Carriage Meadows South at Lorson Ranch Filing 2

PUD Development Plan, Preliminary Plan, Early Grading & Wet Utilities

A PLANNED UNIT DEVELOPMENT FOR CARRIAGE MEADOWS SOUTH AT LORSON RANCH FILING 2

FIRE LANE SIGNAGE DETAIL
NOT TO SCALE

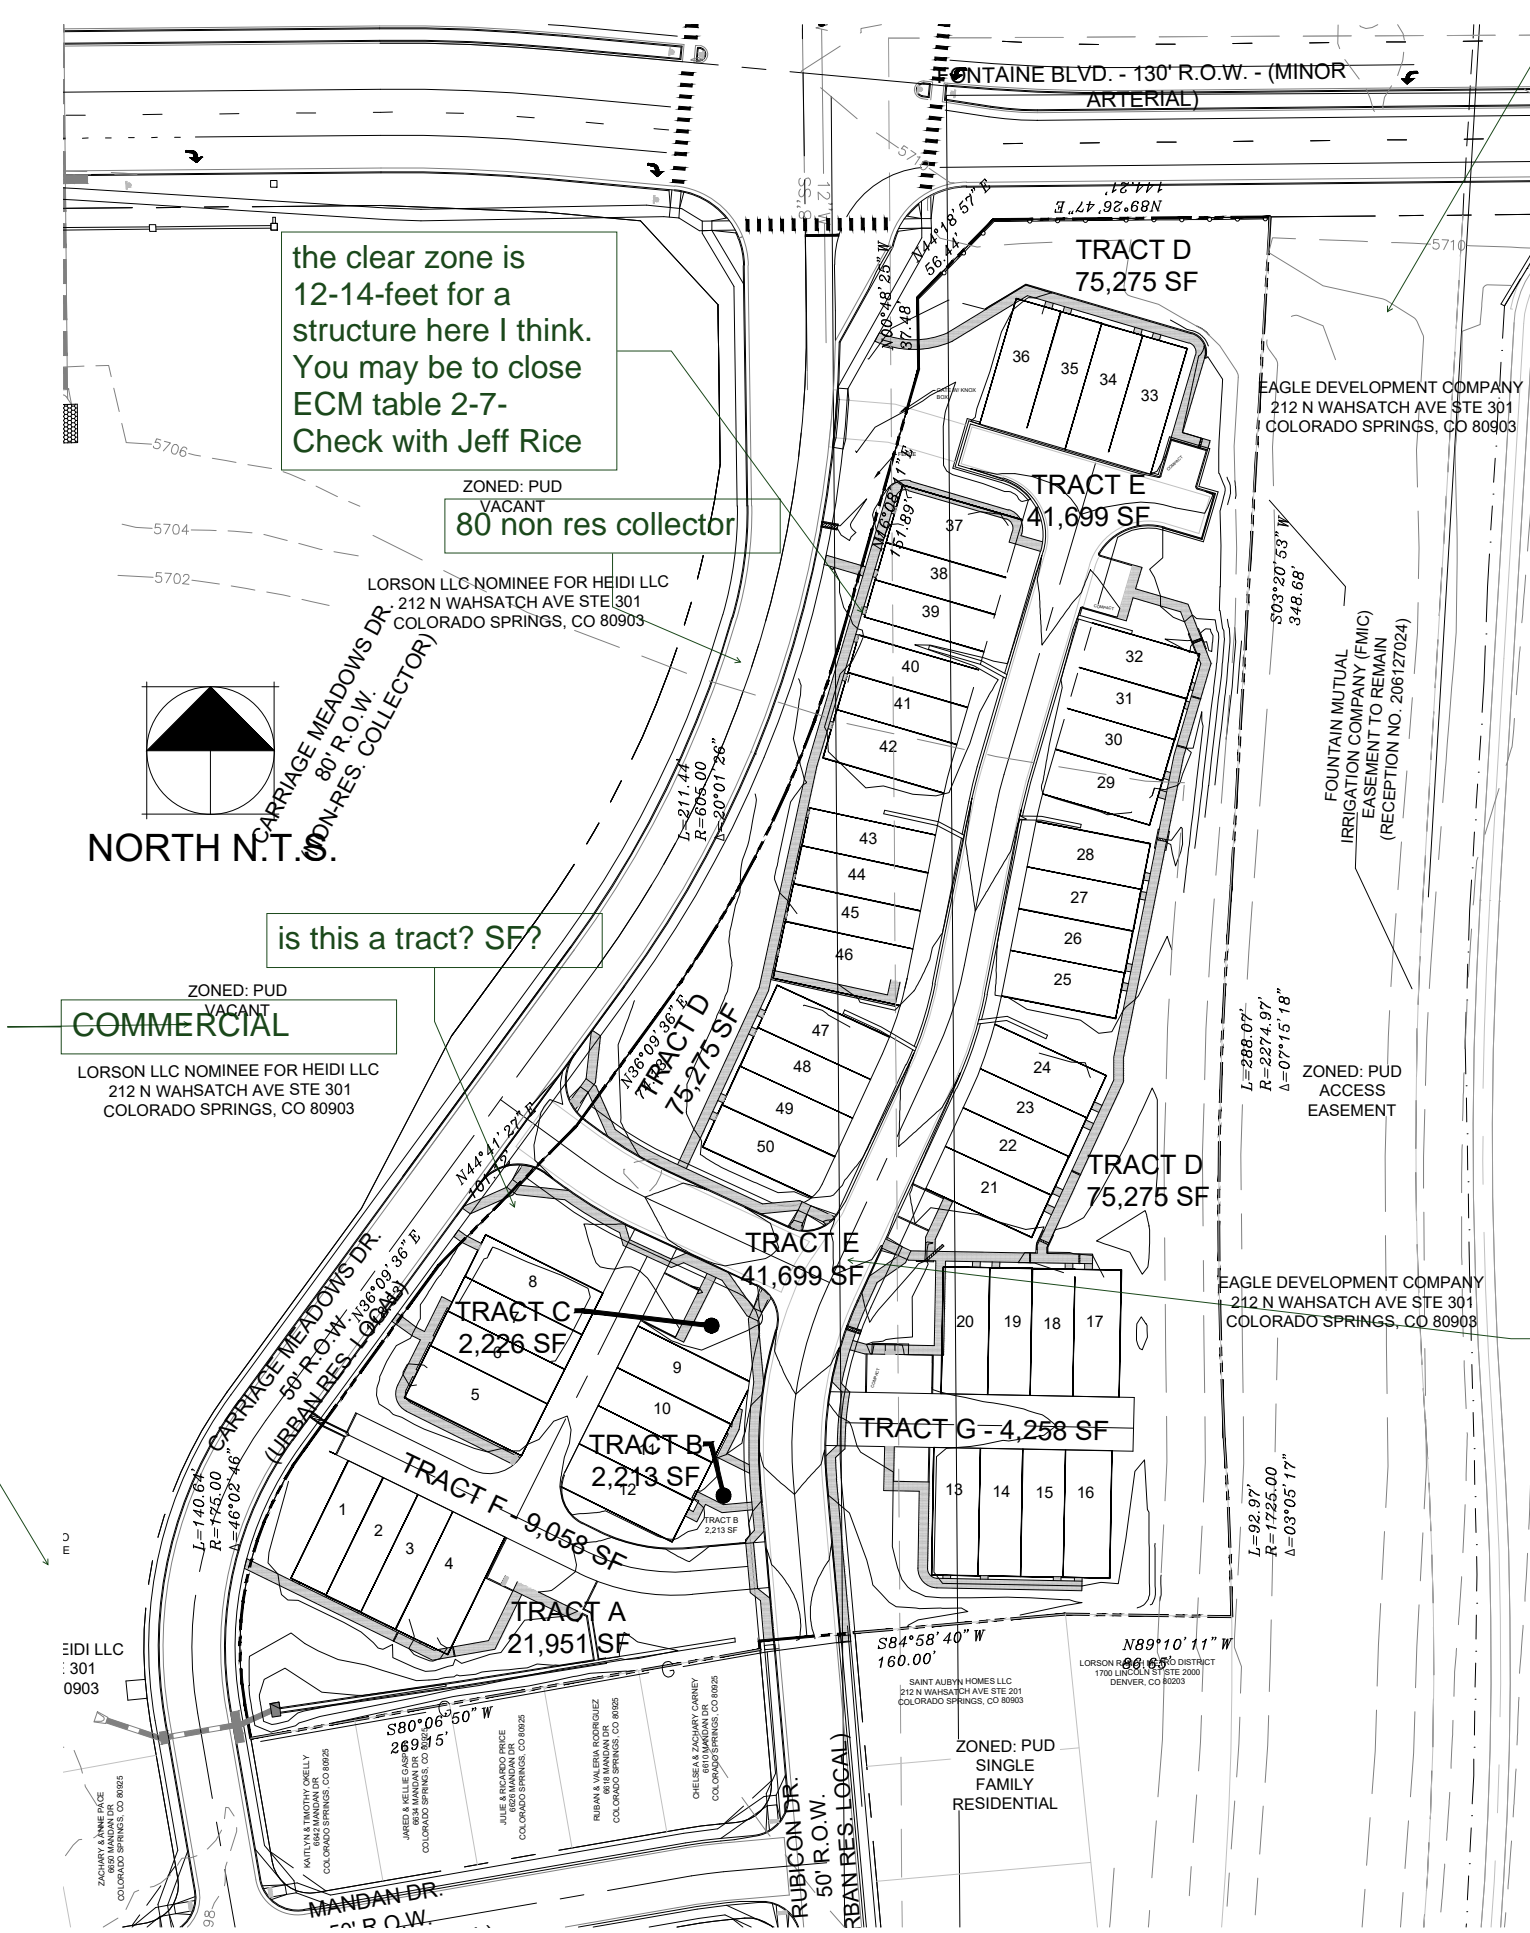
STAFF CONCERN:
If no parking in driveway and no parking on street-where do the people park? when visitors come over or teenagers vehicles? Parking seems inadequate

what is the justification for proposing landscape in County ROW? it should be placed in the 10' landscape setback or 25 foot landscape setback... Are you proposing to utilize the landscape setbacks as open space?

all these comments pertain to each detail to the right:
dimension ALL these details- check to make sure they work with your dim standards and the Code req before resubmitting

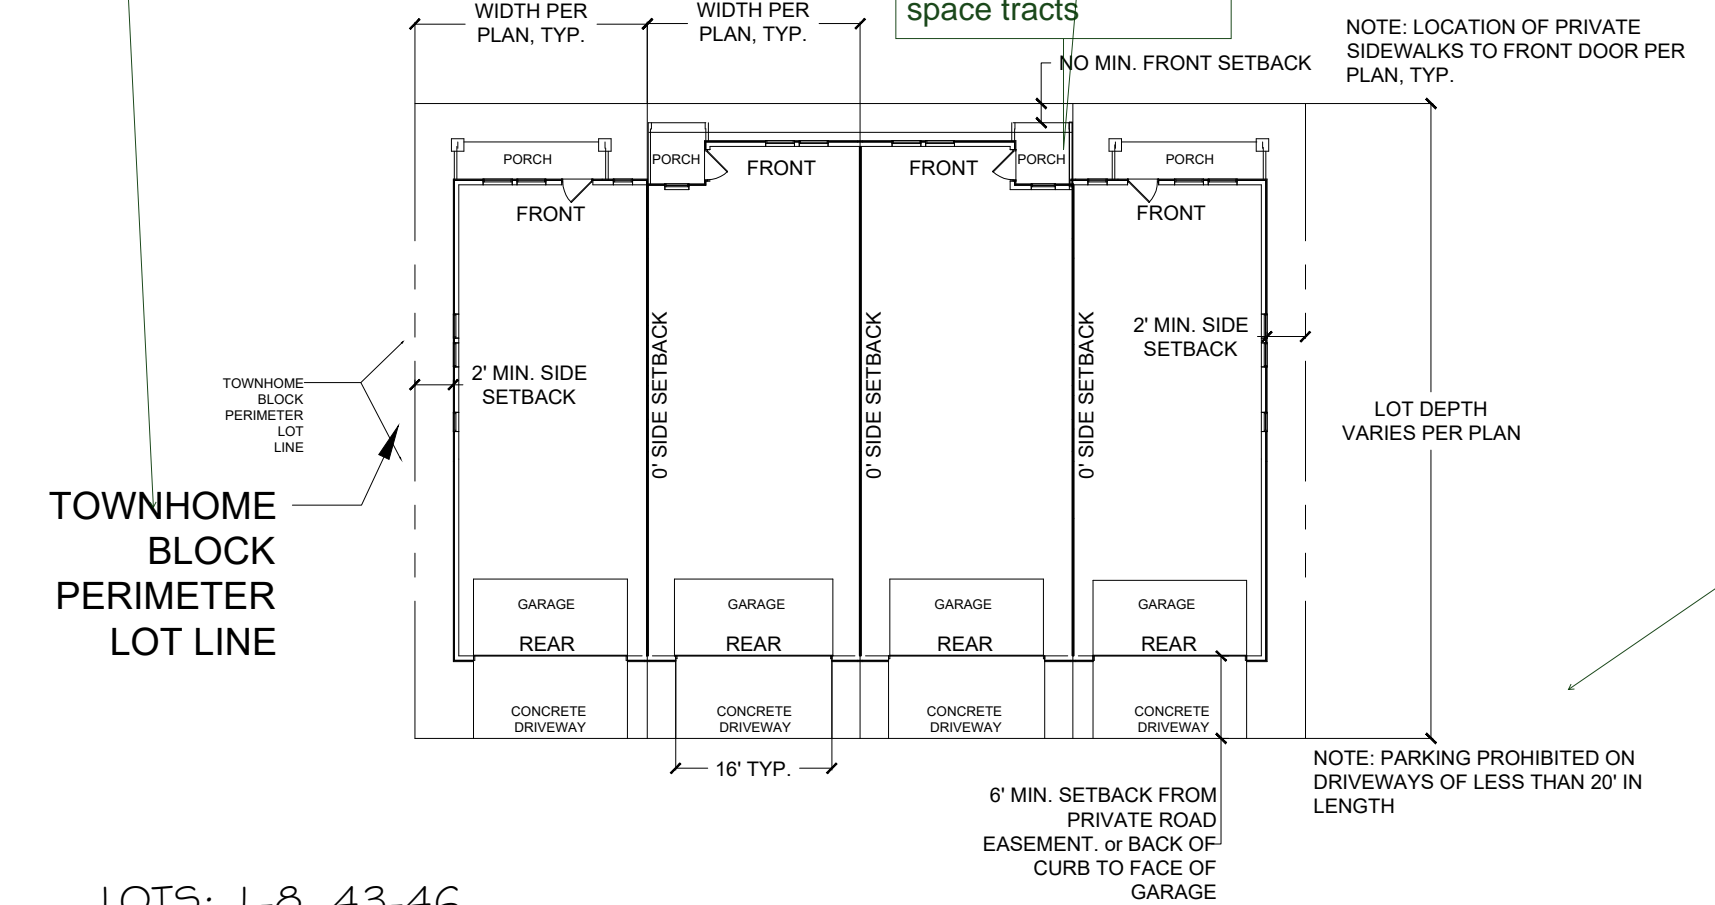
25% of the 10% must be for openspace parkland not drainage per Code...

LOTS: 1-8, 43-46

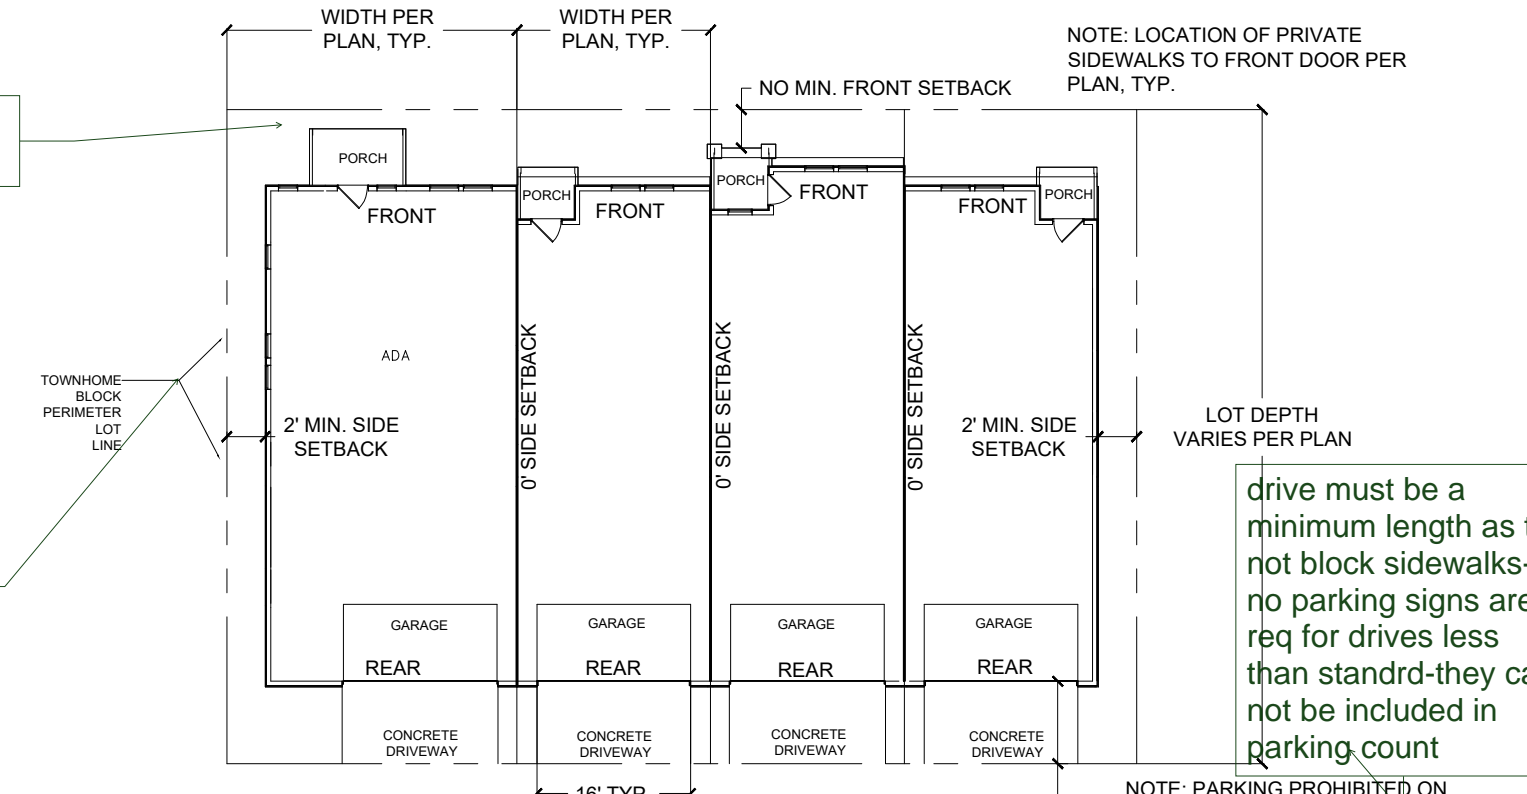
provide the setbacks to the lot lines

The end units may need 5foot side backs. Does PPRBD require 10' foot separation between buildings irrespective of lot lines?

LOTS: 40-42

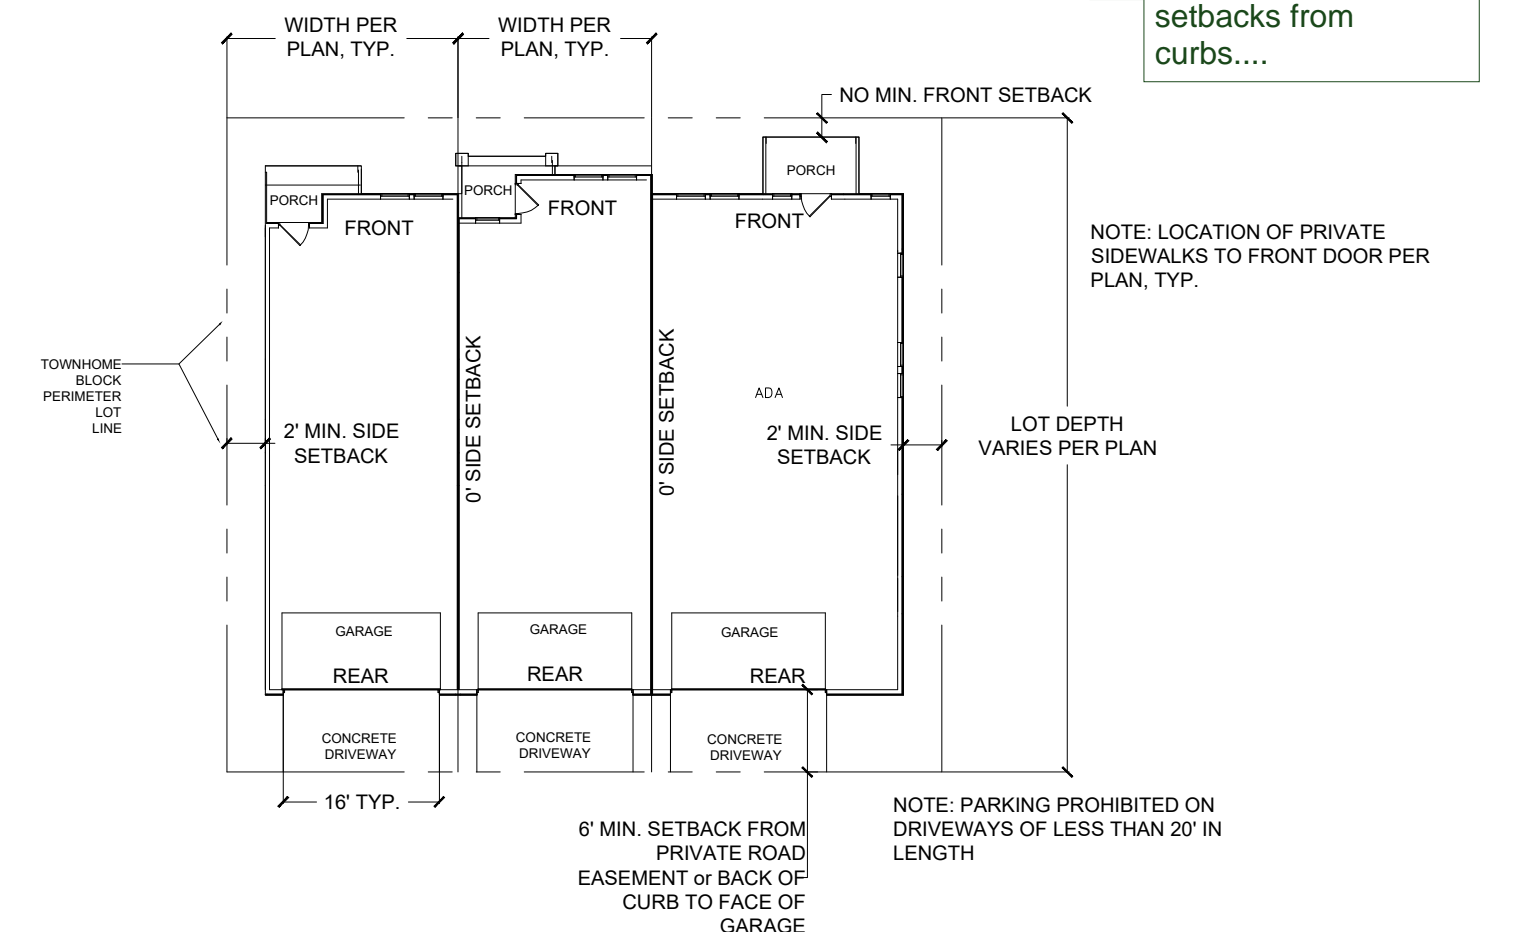
Cars may not hang over driveways or roadways. A PUDMod may be needed- please see standards in Chapter 6.

CARRIAGE MEADOWS SOUTH AT LORSON RANCH FILING 2

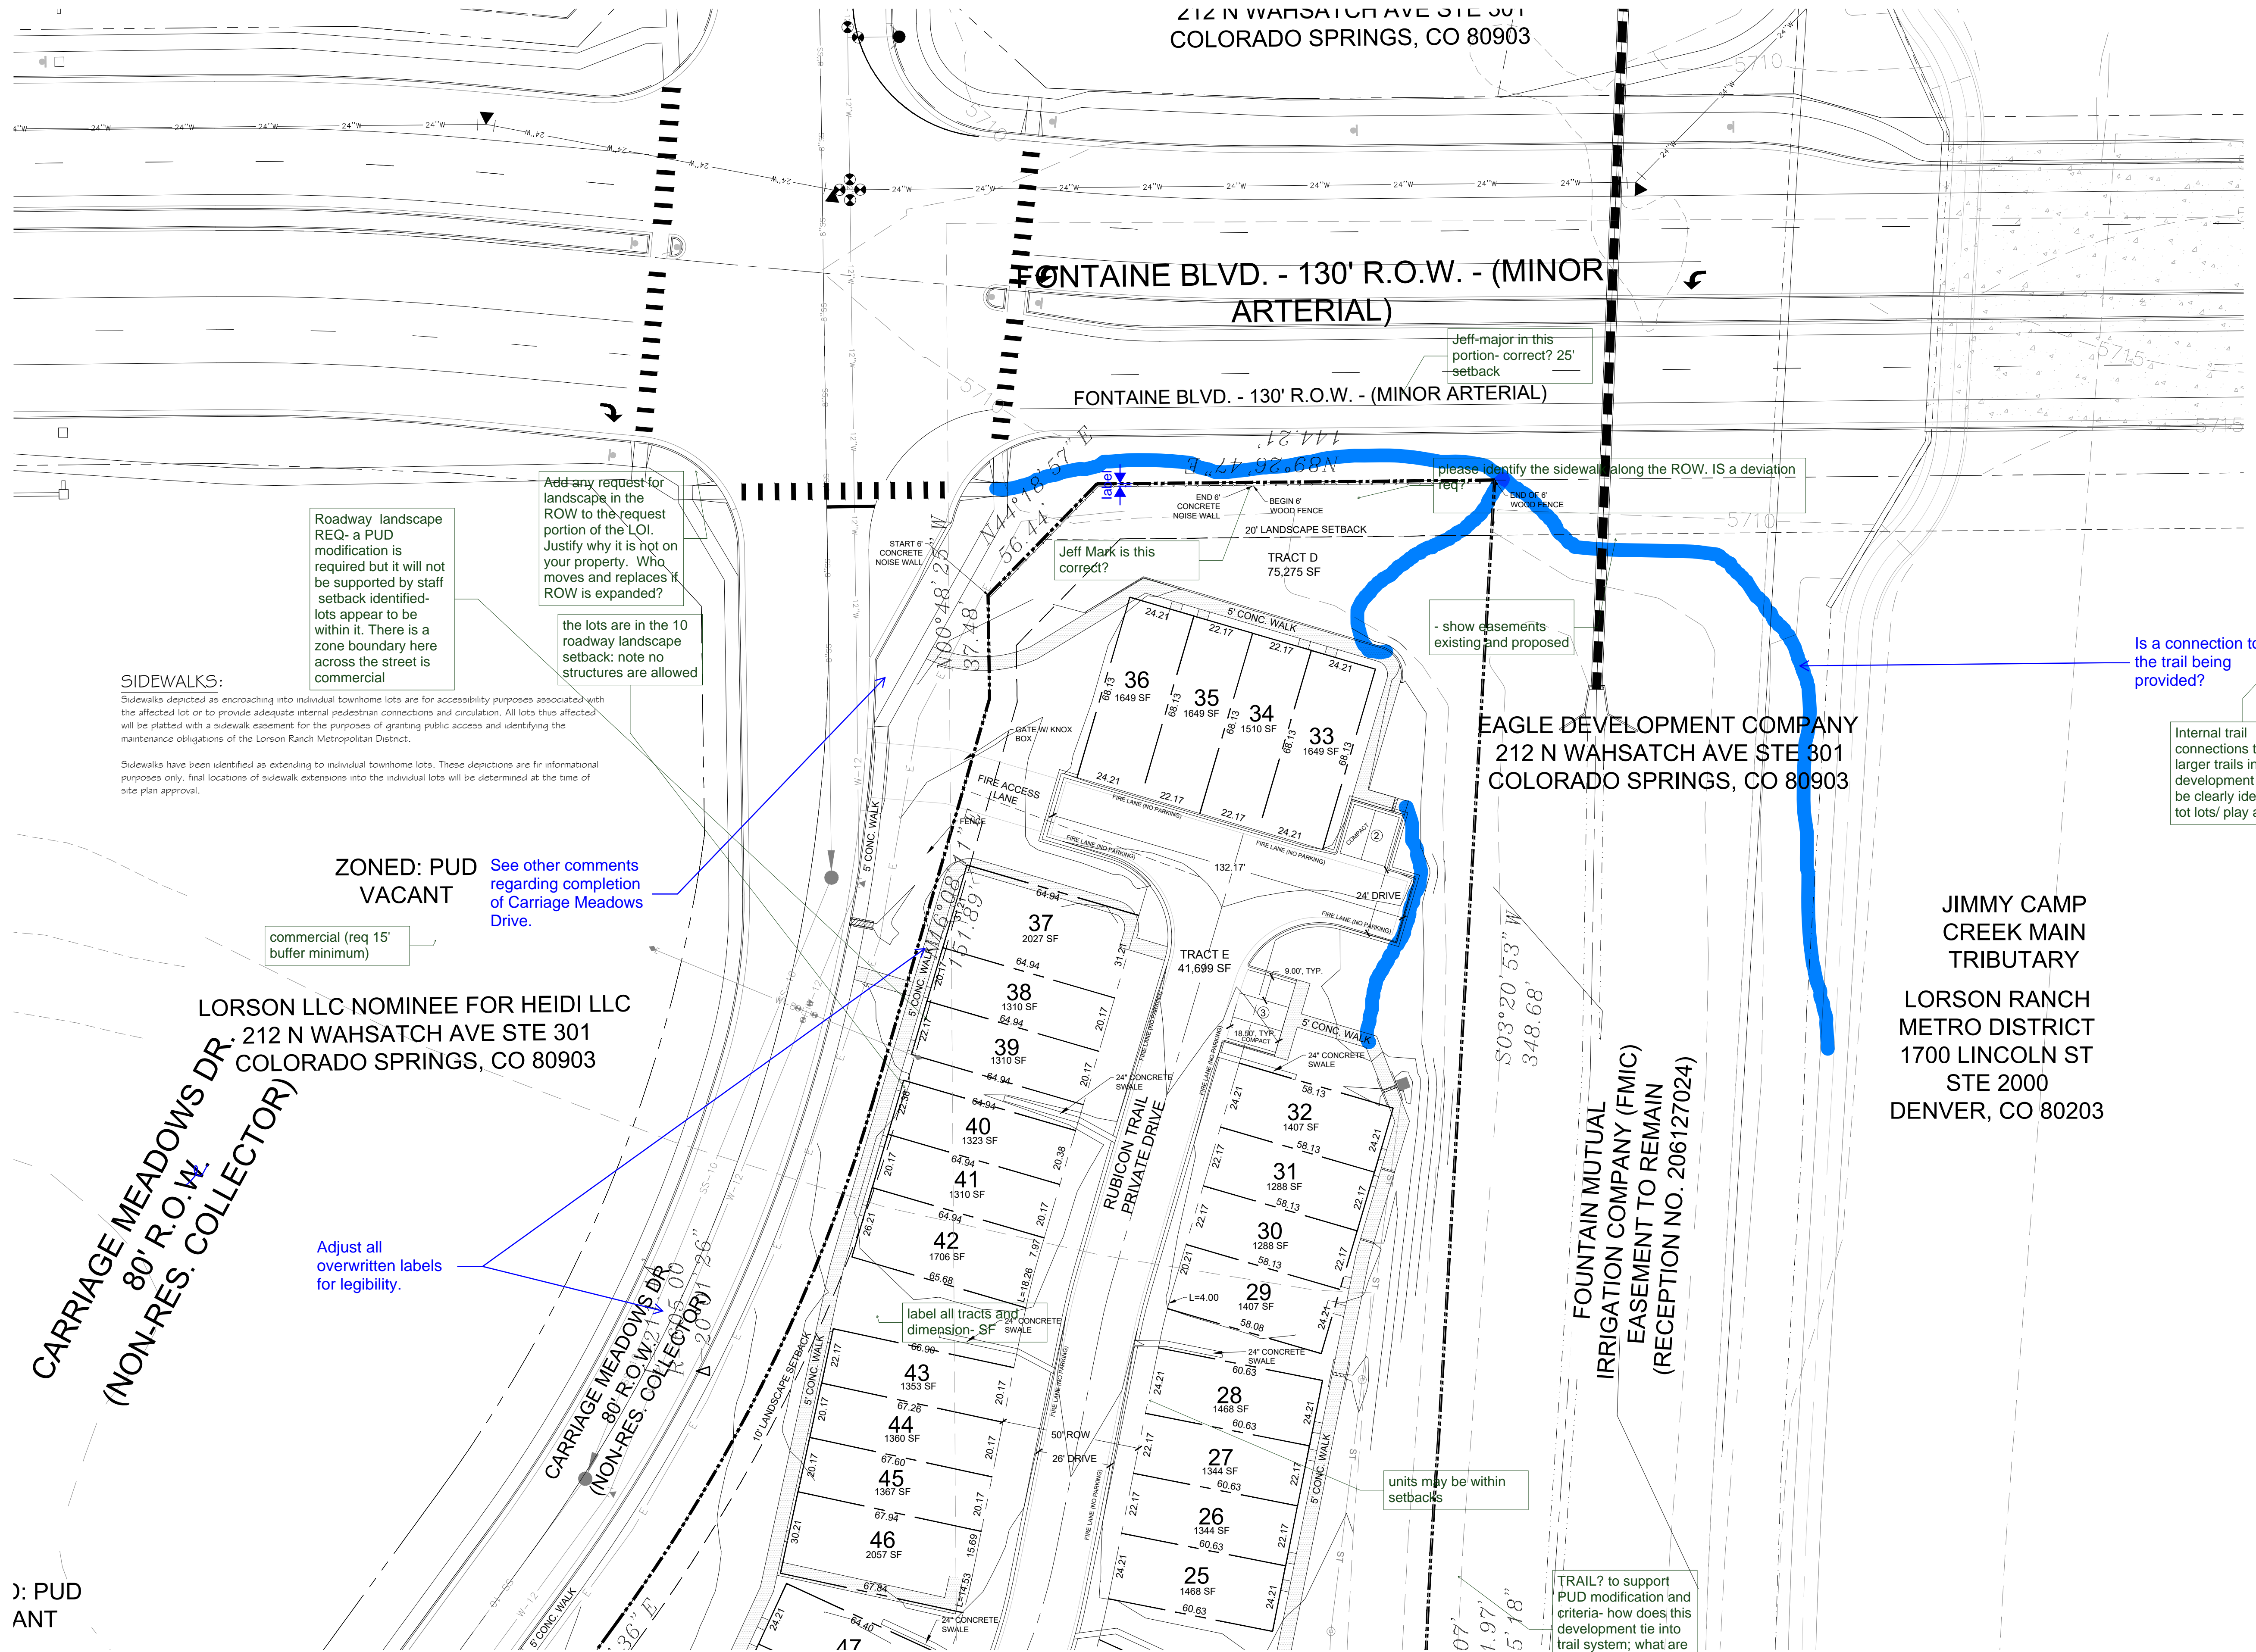
Roadway landscape REQ- a PUD modification is required but it will not be supported by staff setback identified-lots appear to be within it. There is a zone boundary here across the street is commercial

Add any request for landscape in the ROW to the request portion of the LOI. Justify why it is not on your property. Who moves and replaces if ROW is expanded?
the lots are in the 10 roadway landscape setback: note no structures are allowed

Adjust all overwritten labels for legibility.

label all tracts and dimension- SF

units may be within setbacks

TRAIL? to support PUD modification and criteria- how does this development tie into trail system; what are the amenities as required per criteria?
